Development Review Division

SUBJECT: SP21-063; Douglas 234 F6 L1 - Gas and Convenience Store
Review Comments 01

CONVENIENCE STORE SITE PLAN

LOT 1 OF DOUGLAS 234 FILING NO. 6

WEST ELEVATION

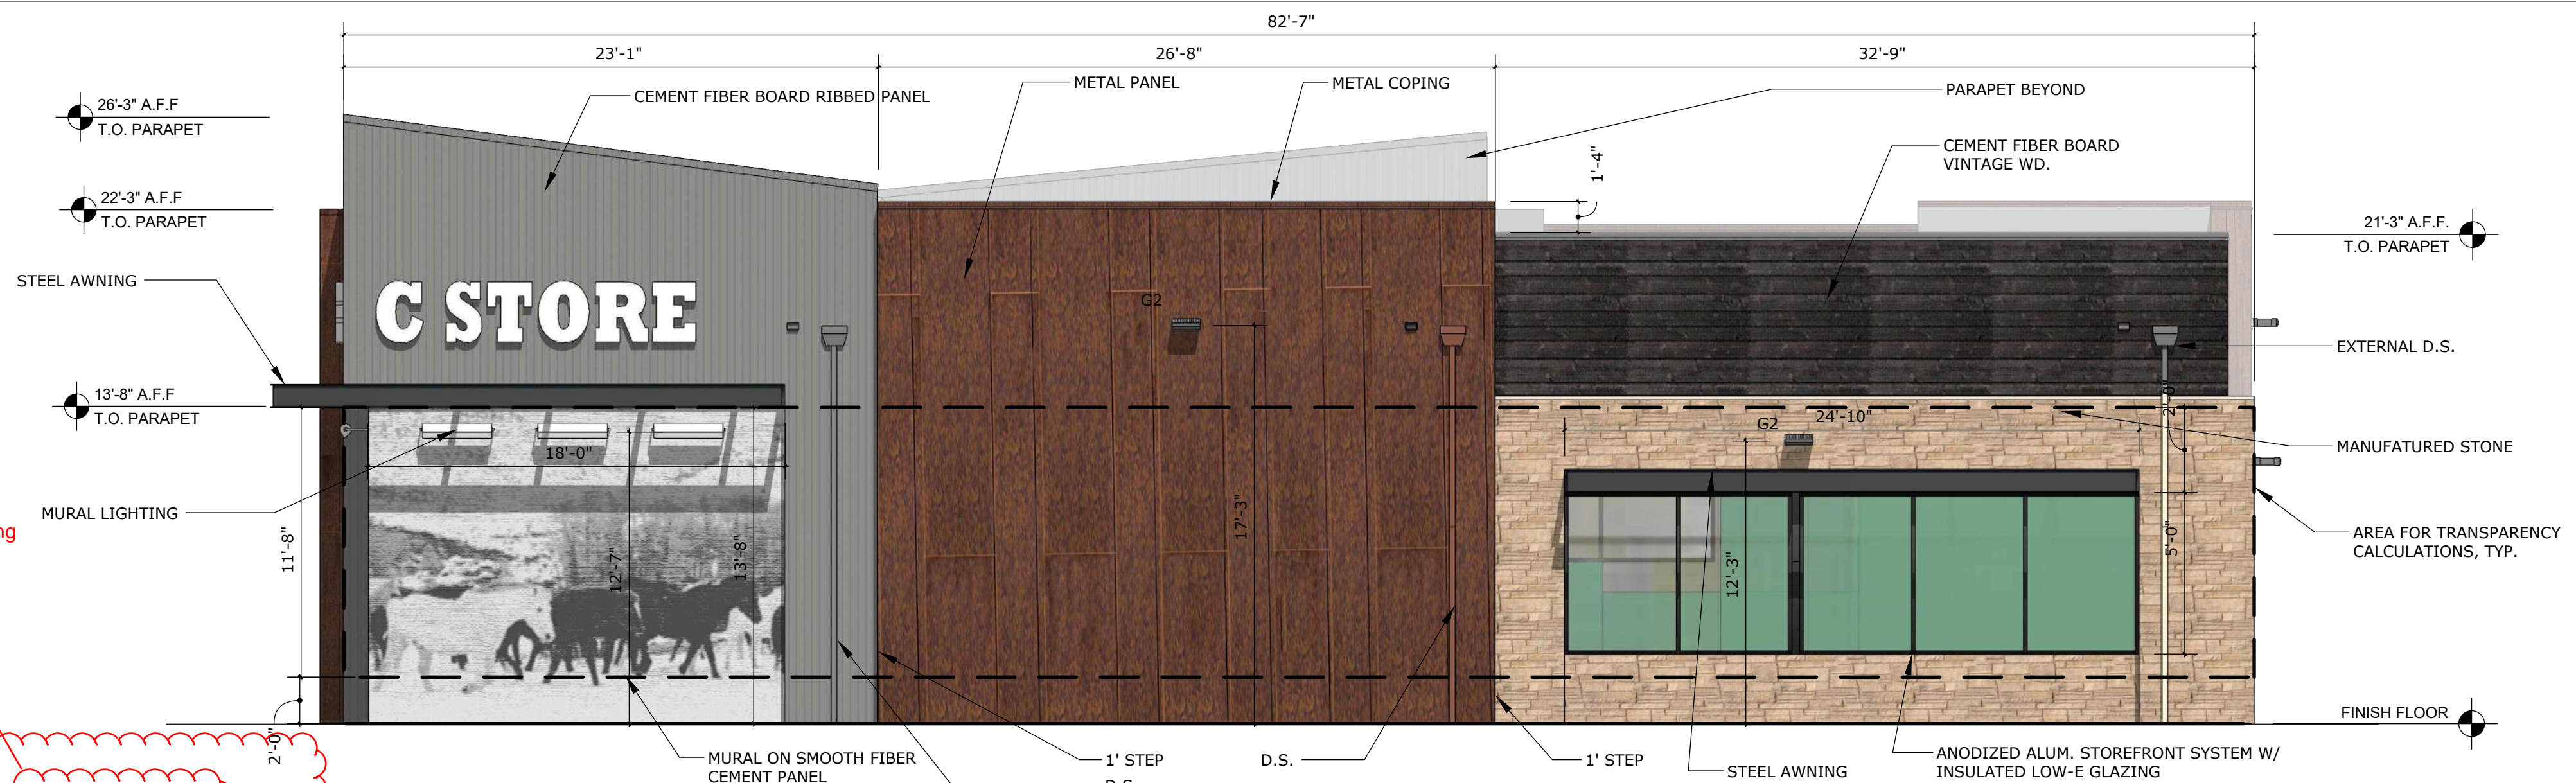
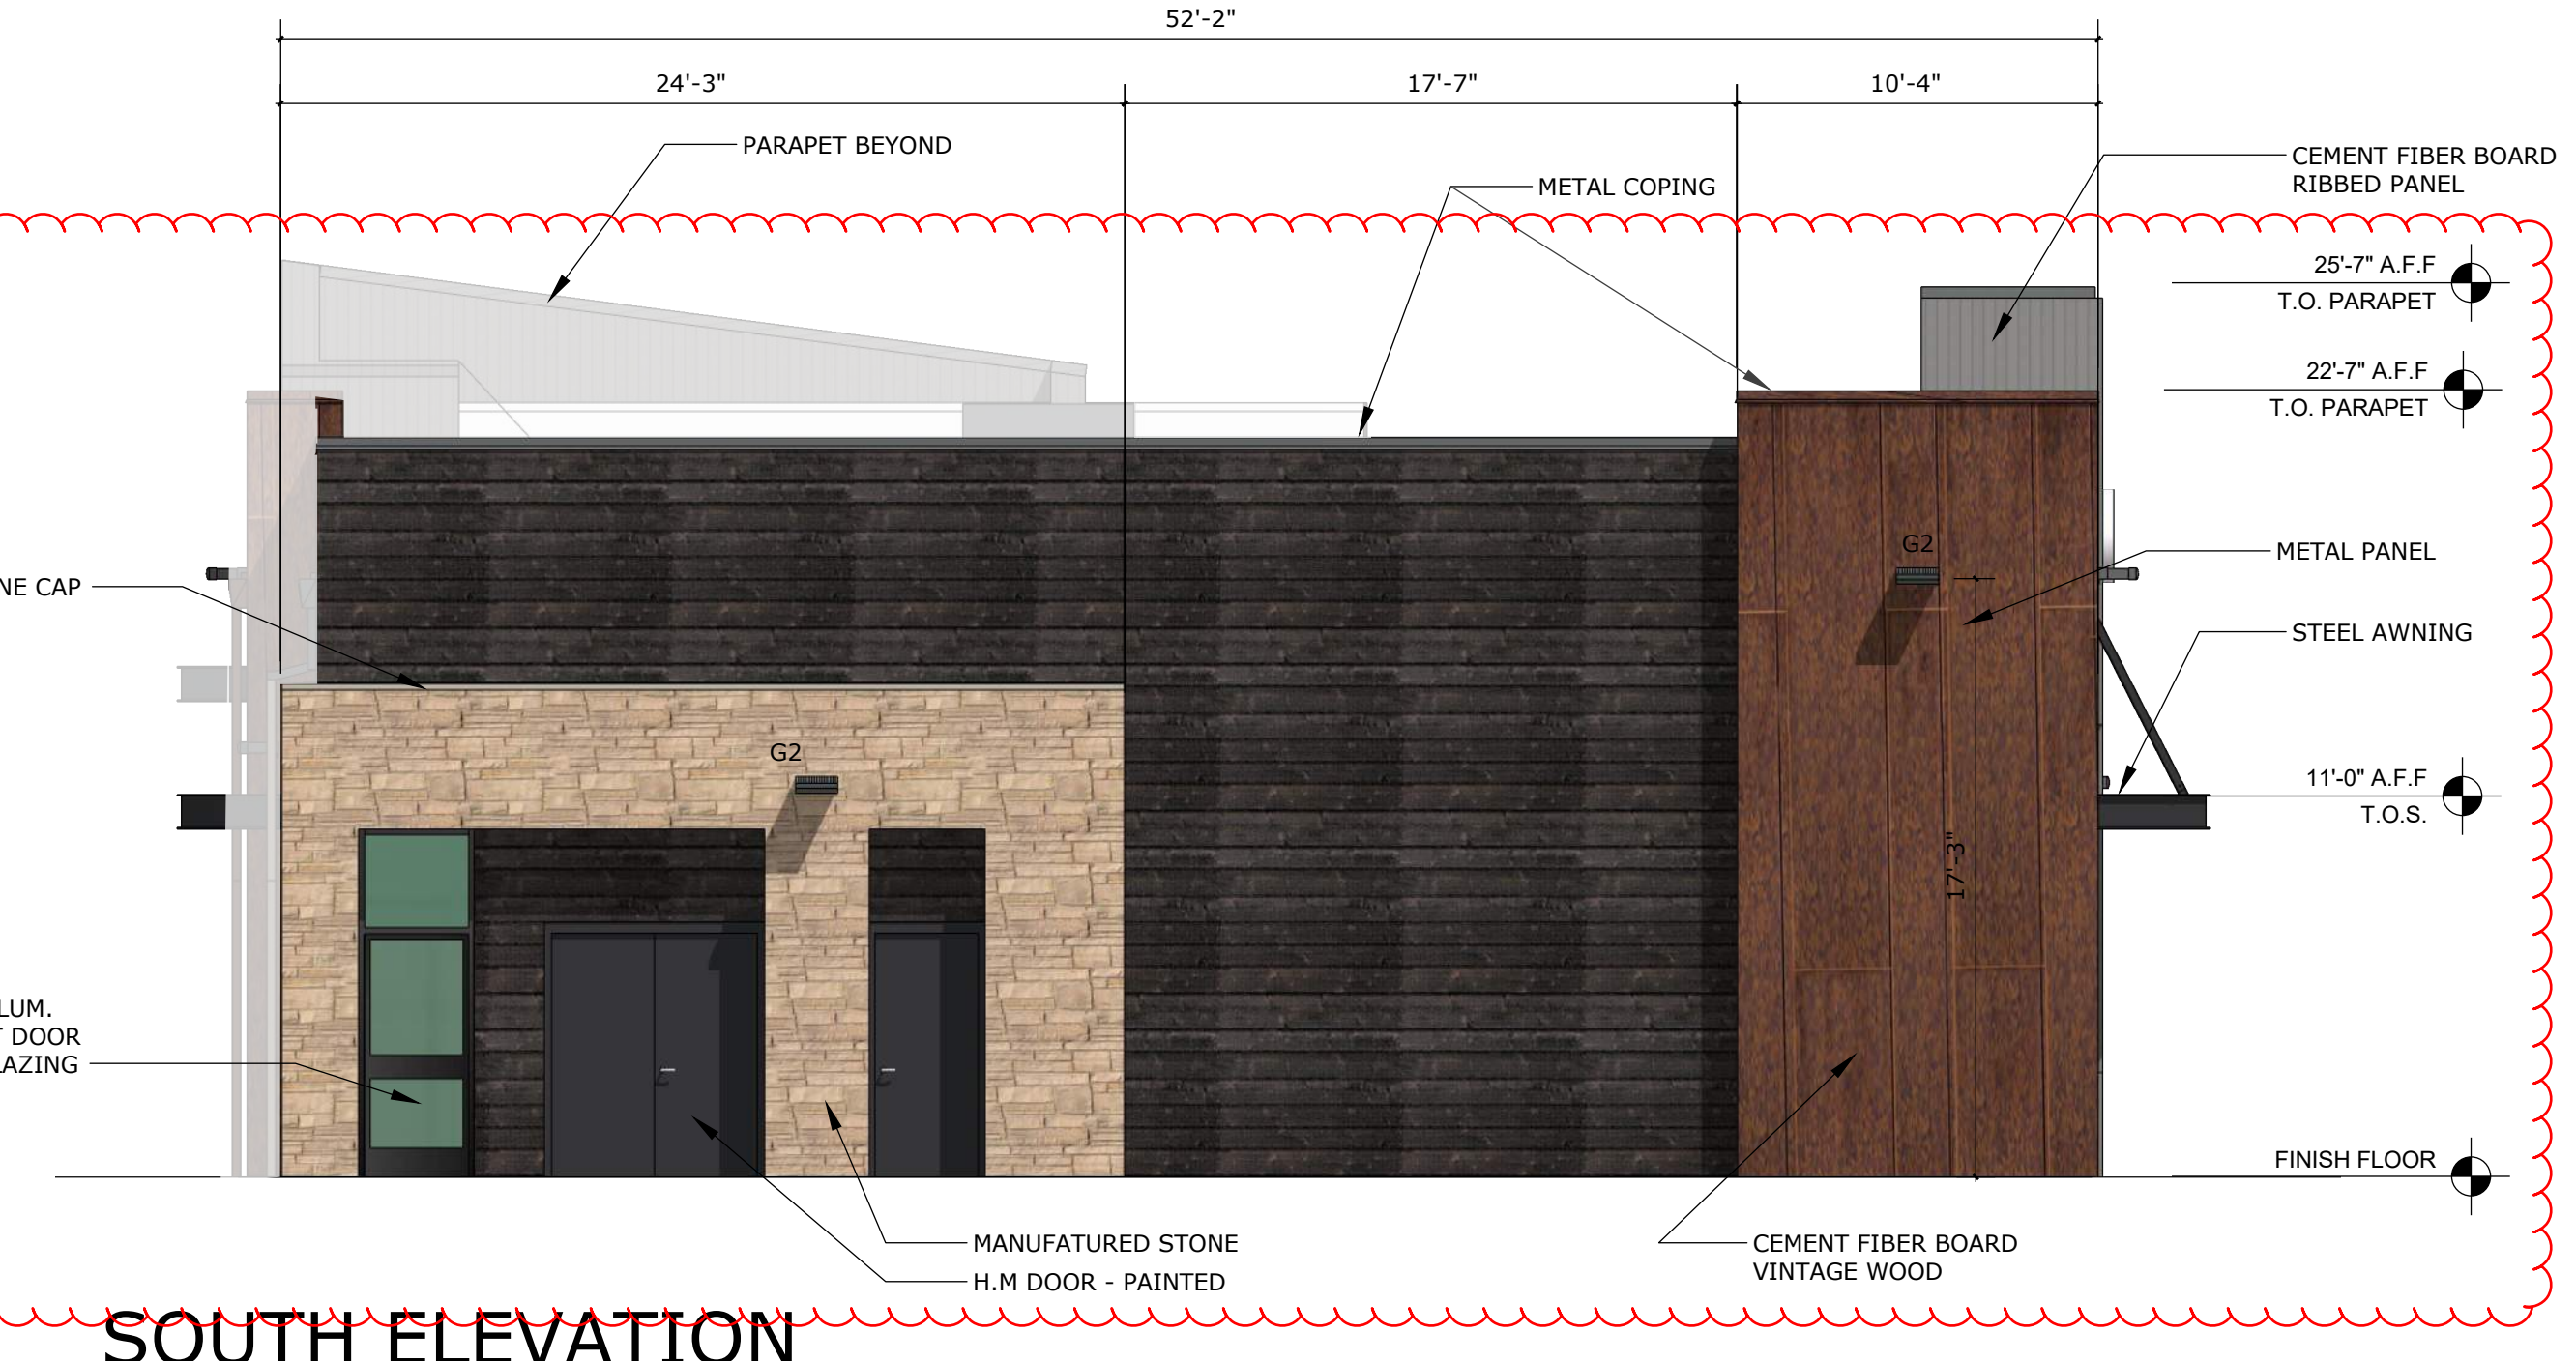
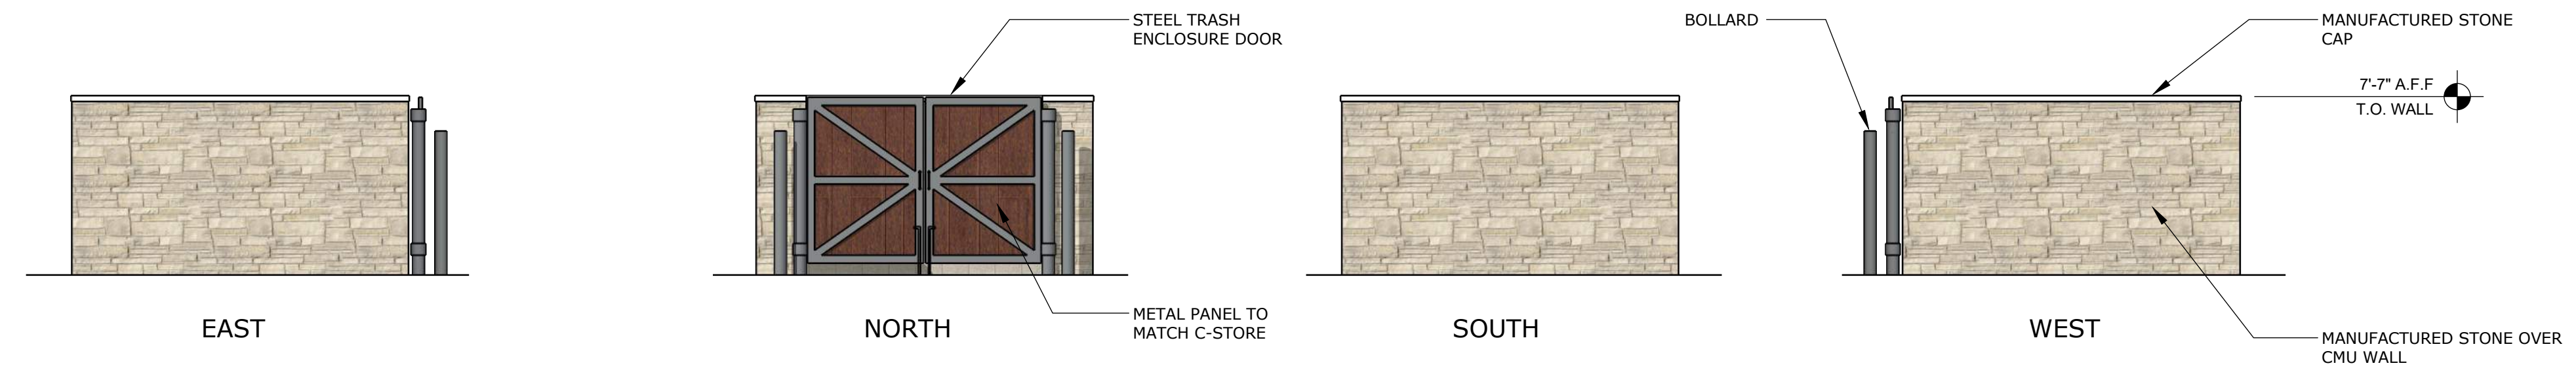
Please work out the math for me here. When I do the calcs. I get a similar number based on your dimensions for the mural but almost 50 sf difference for the windows. The window appears to be dimensions at 5'-0" by 24'-10" which = 124.165 sf, not 214 as shown below? I think it may be you are not showing 2 additional feet of window under the awning?

Where are you getting 961 from?

Where/how are you getting 792 from-show calc?

Please note on all relevant sheets that signage is a place holder and will be obtained under separate permit.
